# PARKER AND PINE RETAIL PINE LANE AND S. PARKER ROAD SITE PLAN

**SITE PLAN SUBMITTAL**

**SITE PLAN COVER  
SHEET**

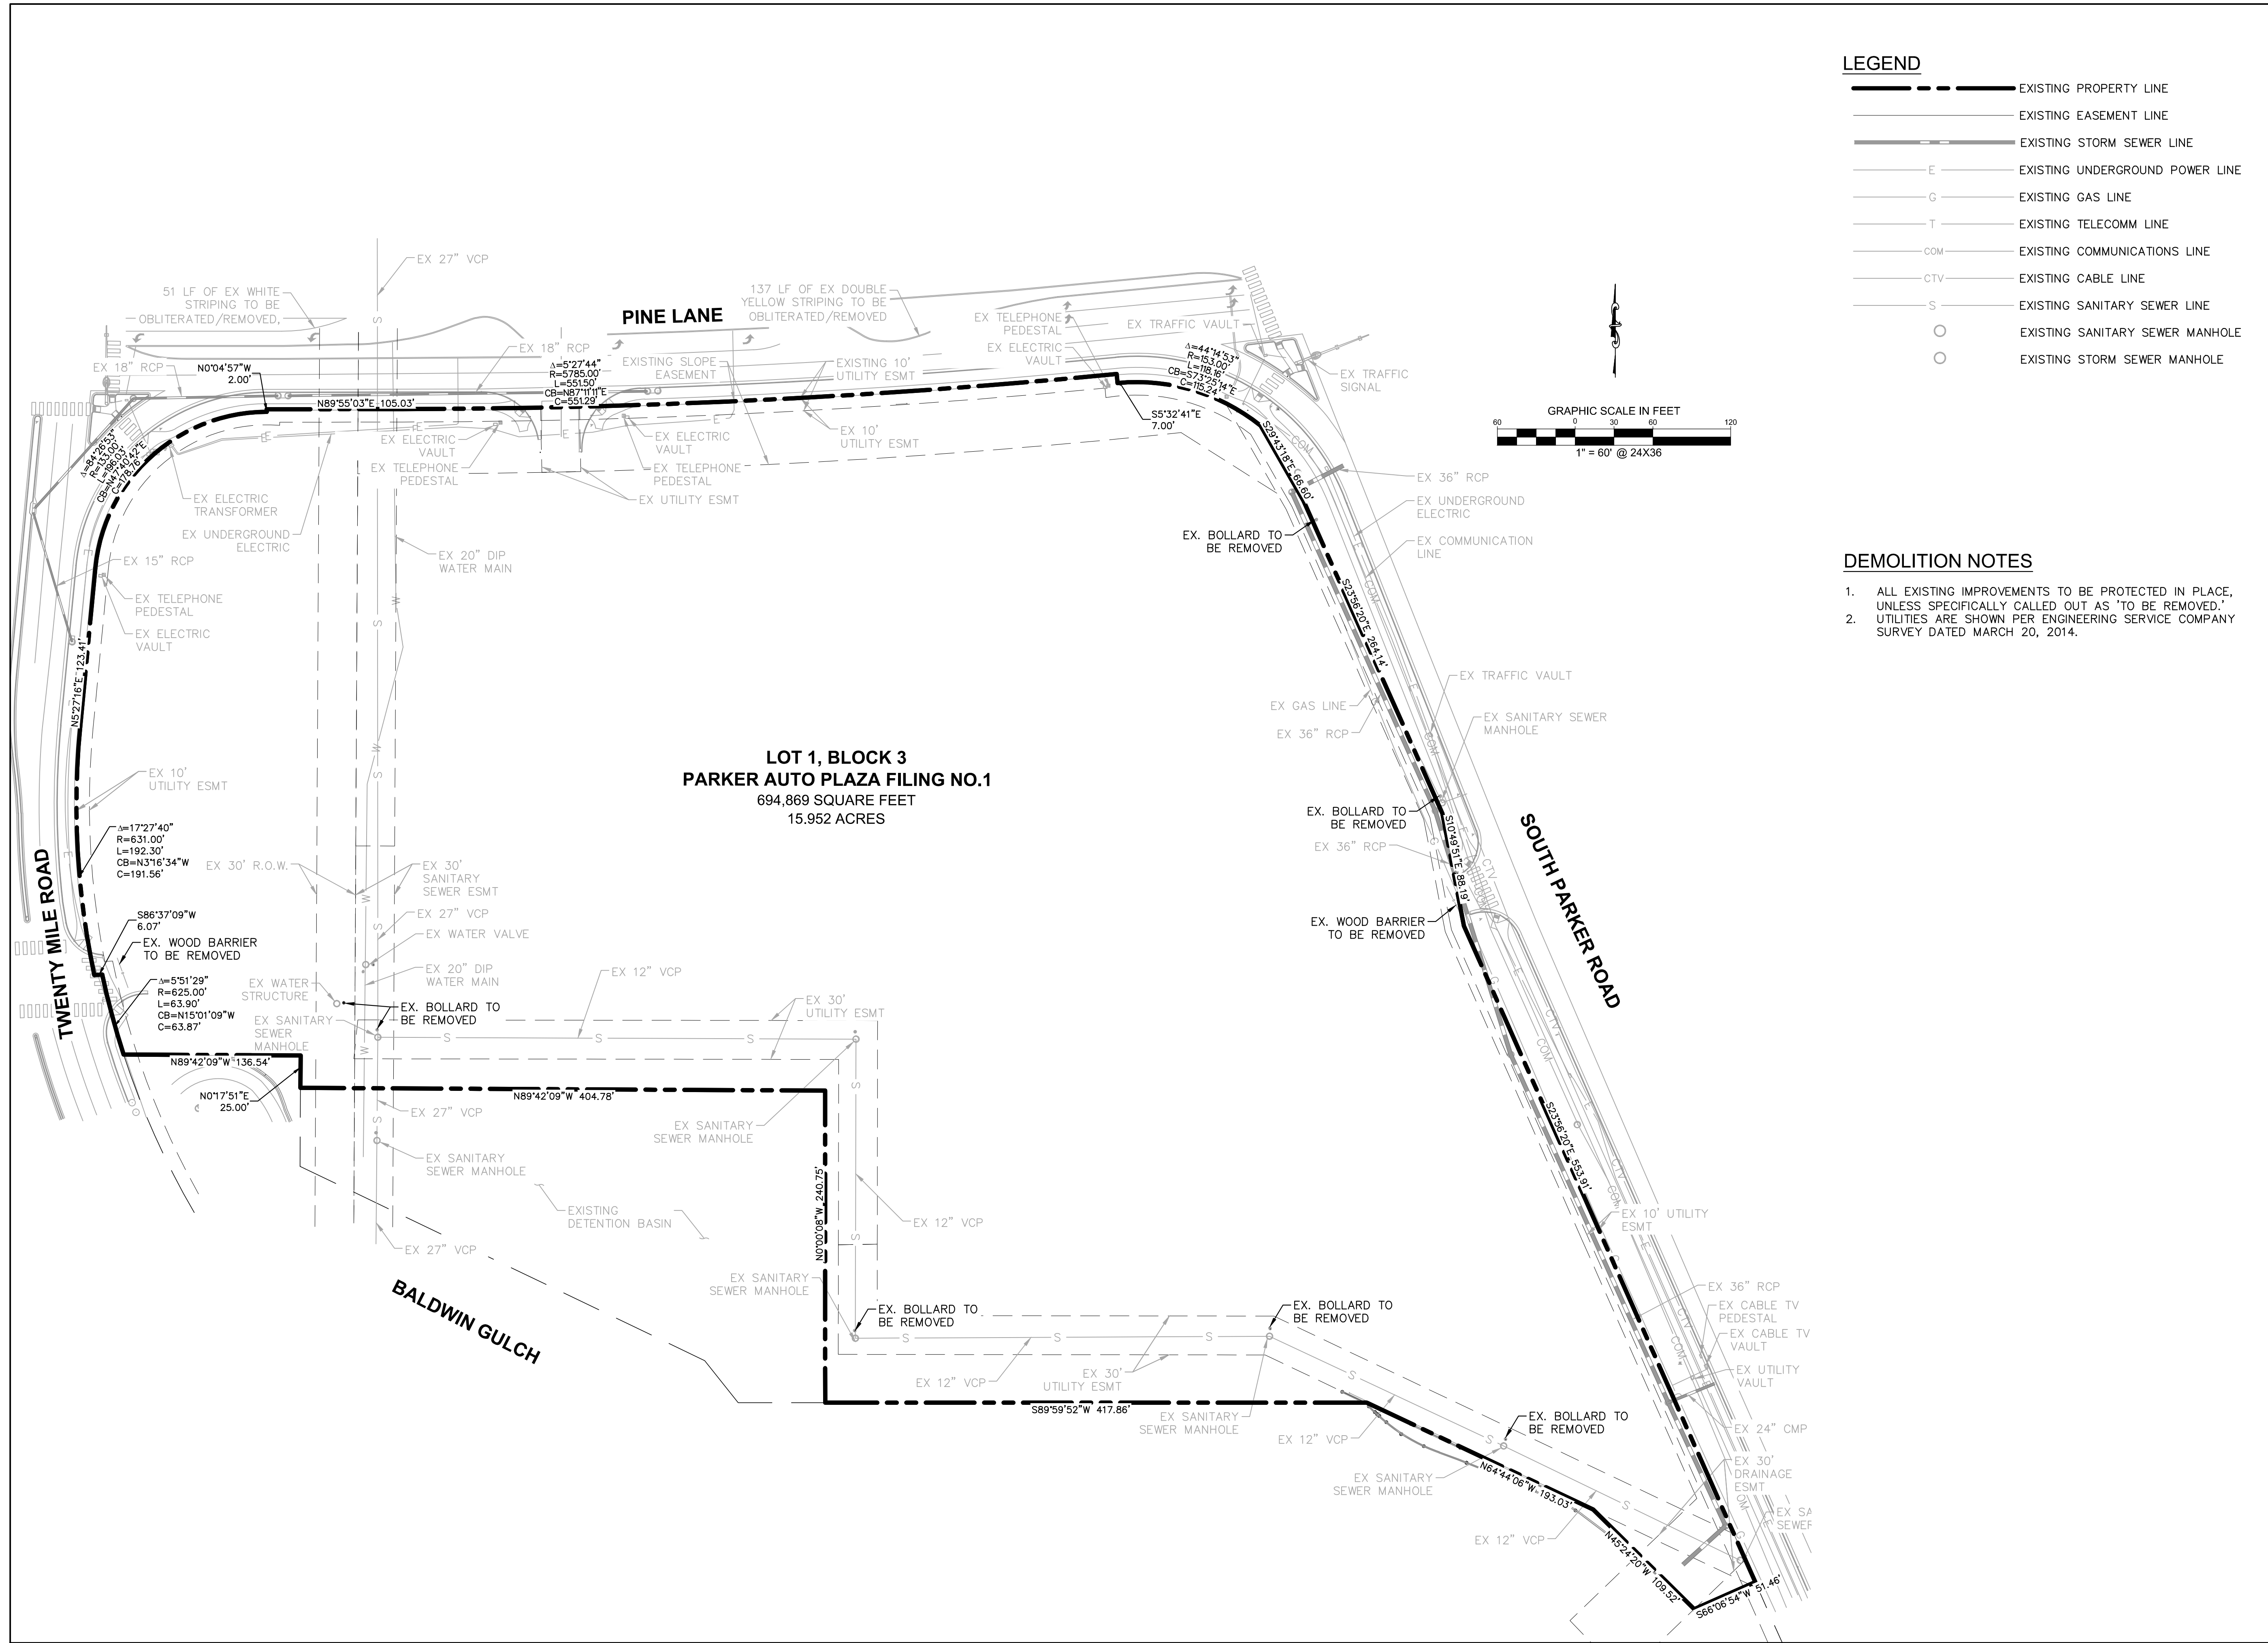
All Drainage Easements and Sight  
Distance Easements will be required by  
separate document.

Include the Signing and Striping Plan

Sheet Title:  
**LANDSCAPE PLAN**

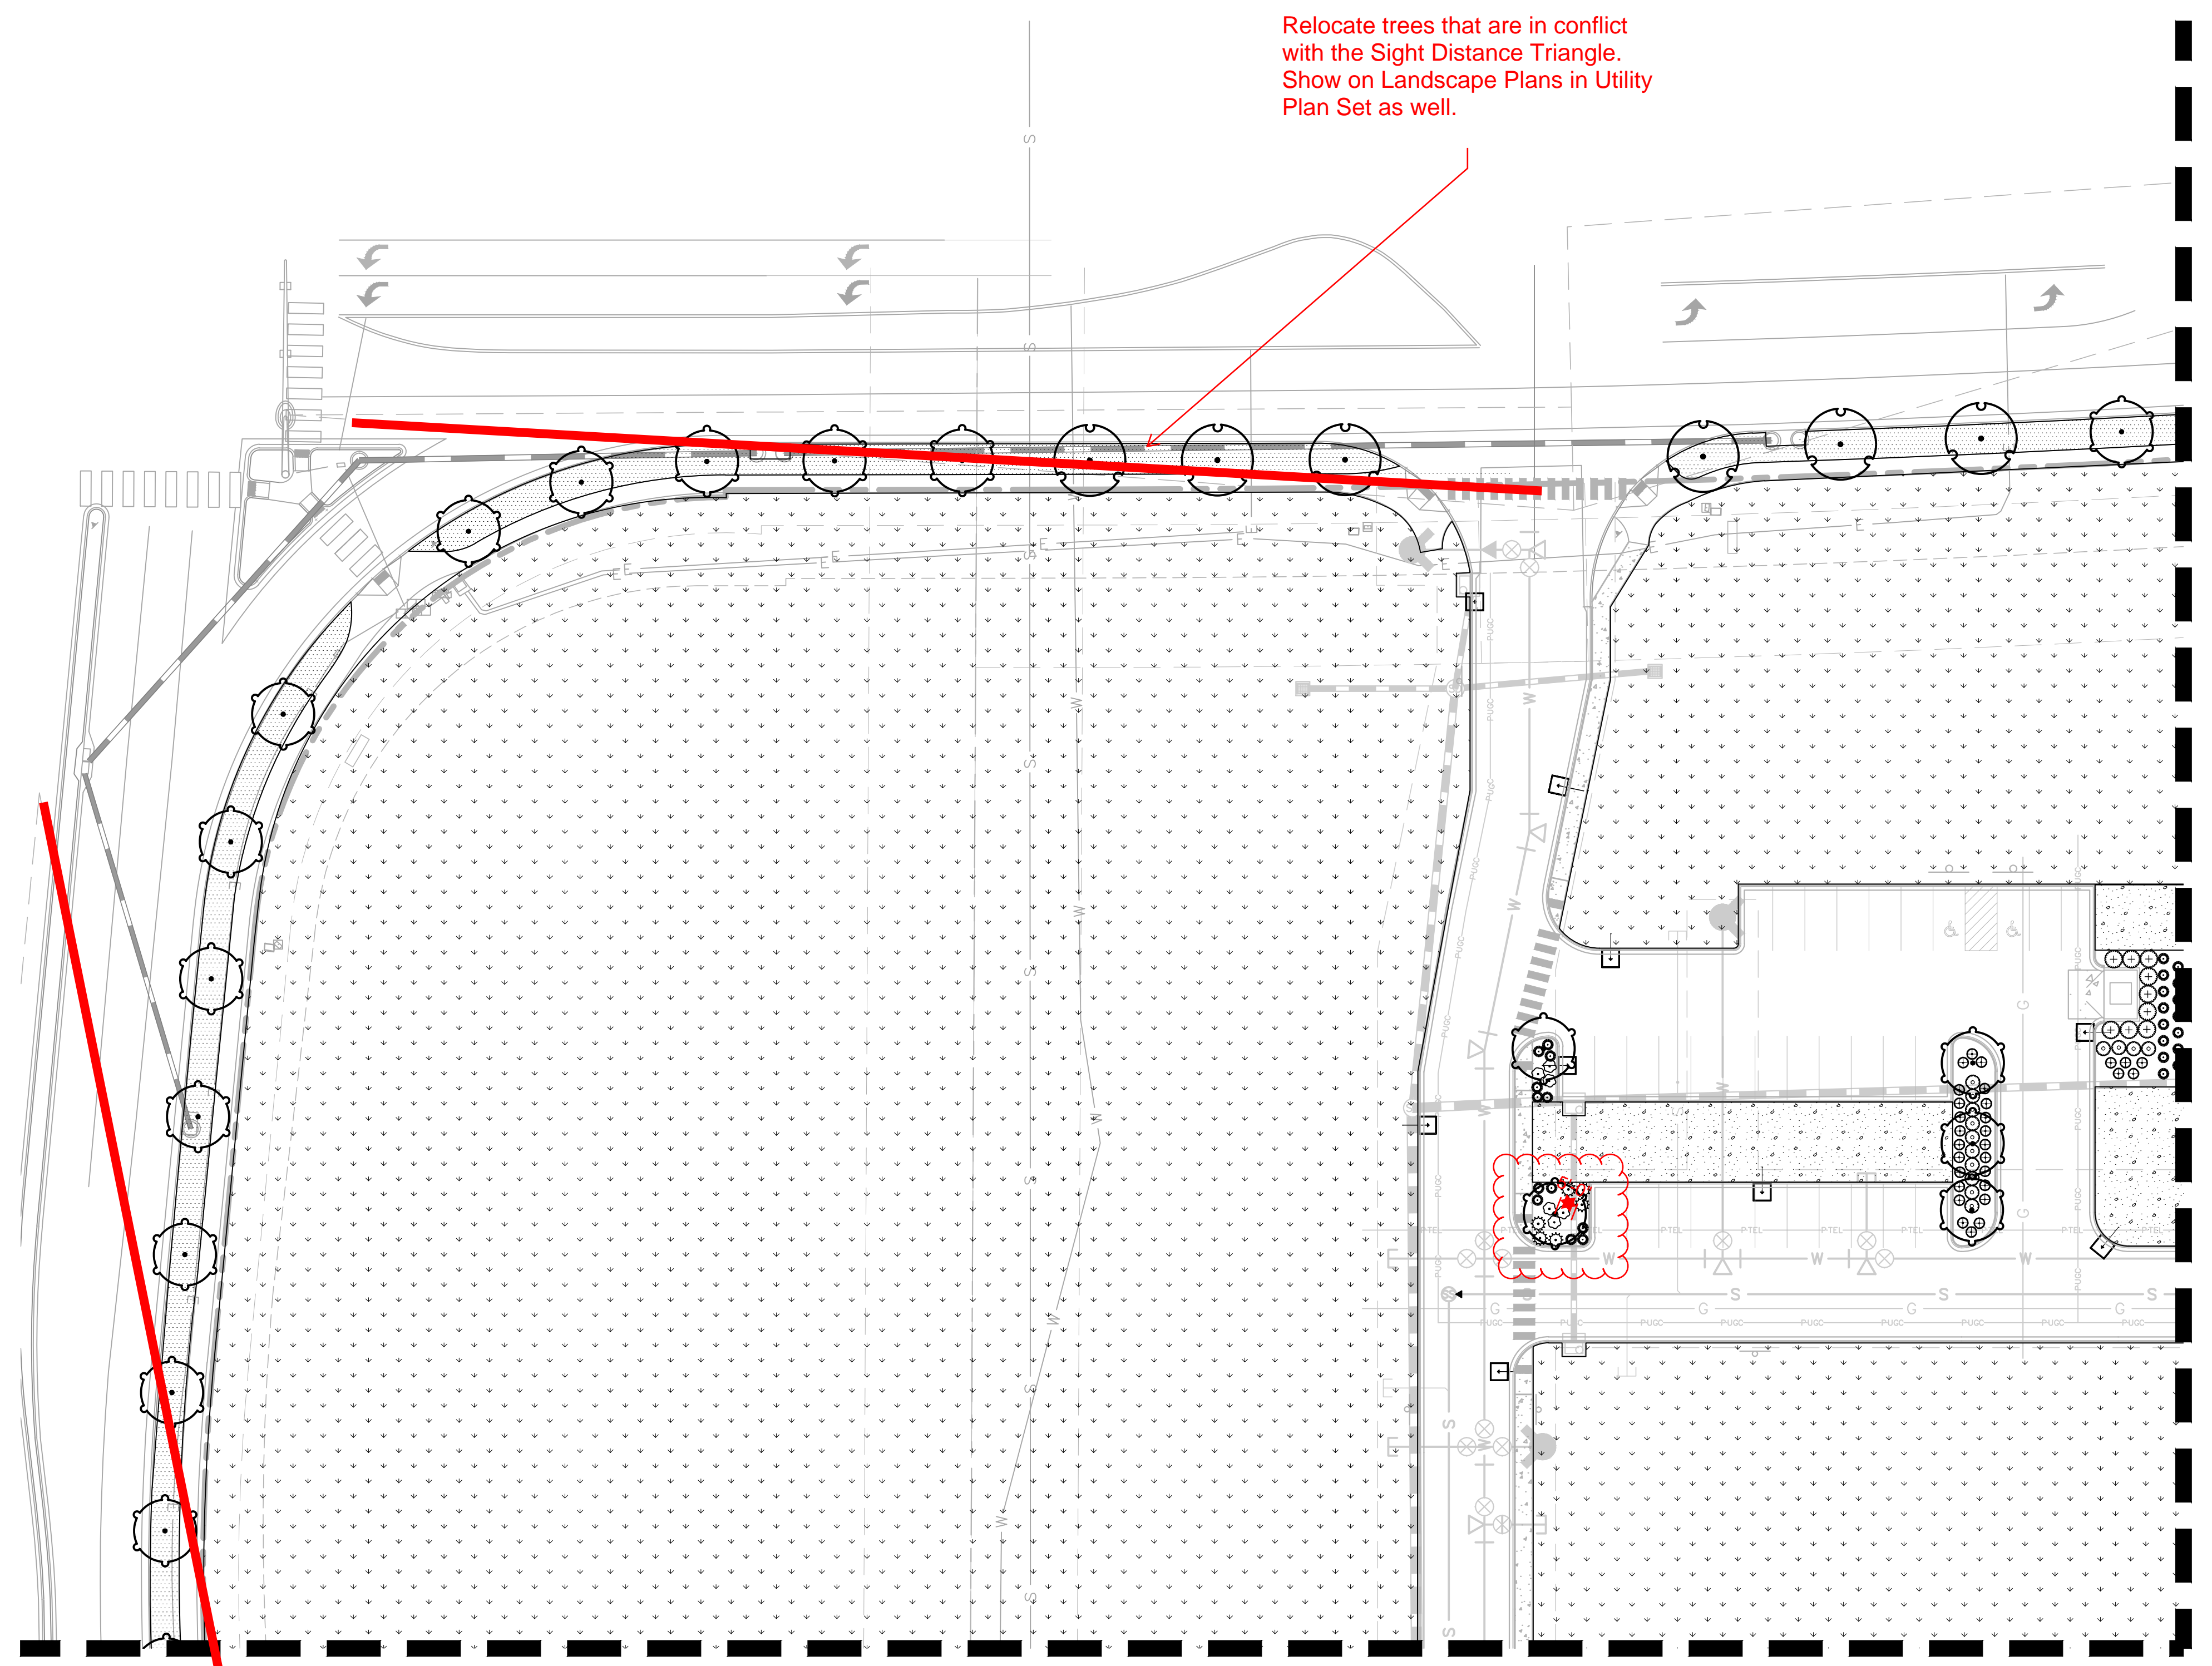
Relocate trees that are in conflict with the Sight Distance Triangle. Show on Landscape Plans in Utility Plan Set as well.

Ensure 10 feet separation from storm pipe to tree

Relocate trees that are in conflict with the Sight Distance Triangle. Show on Landscape Plans in Utility Plan Set as well.

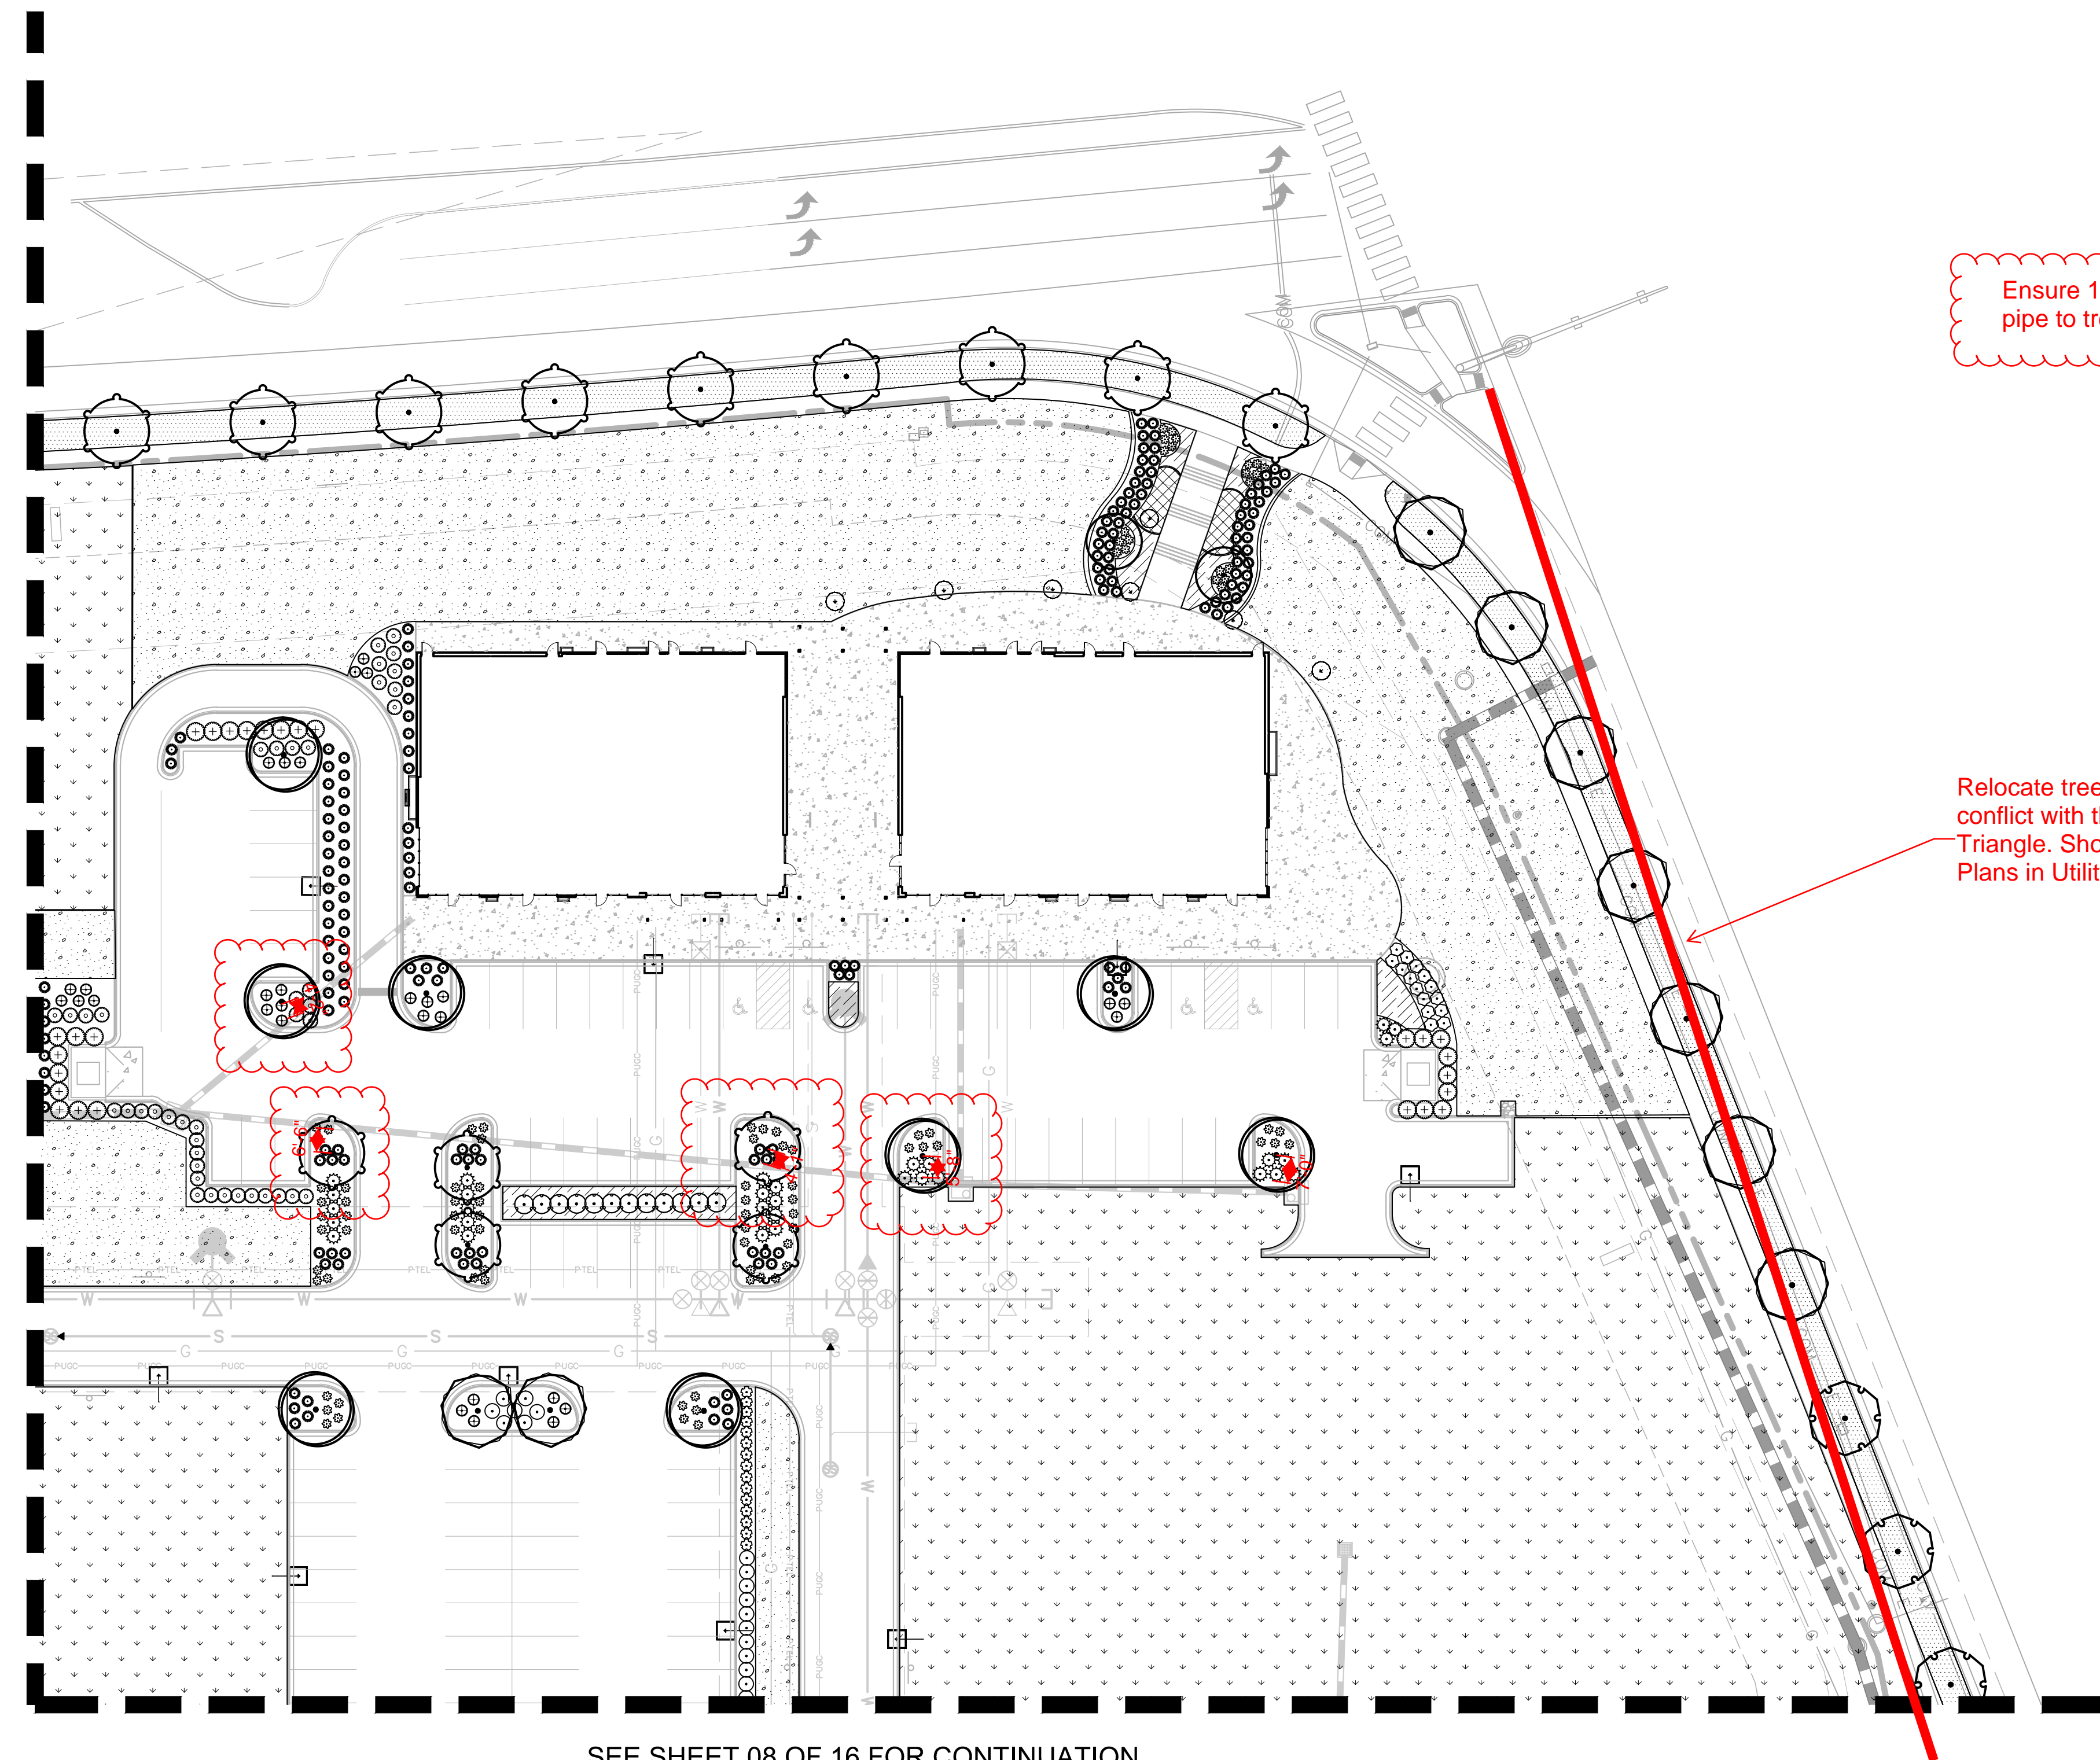
Ensure 10 feet separation from storm pipe to tree

Relocate trees that are in conflict with the Sight Distance Triangle. Show on Landscape Plans in Utility Plan Set as well.
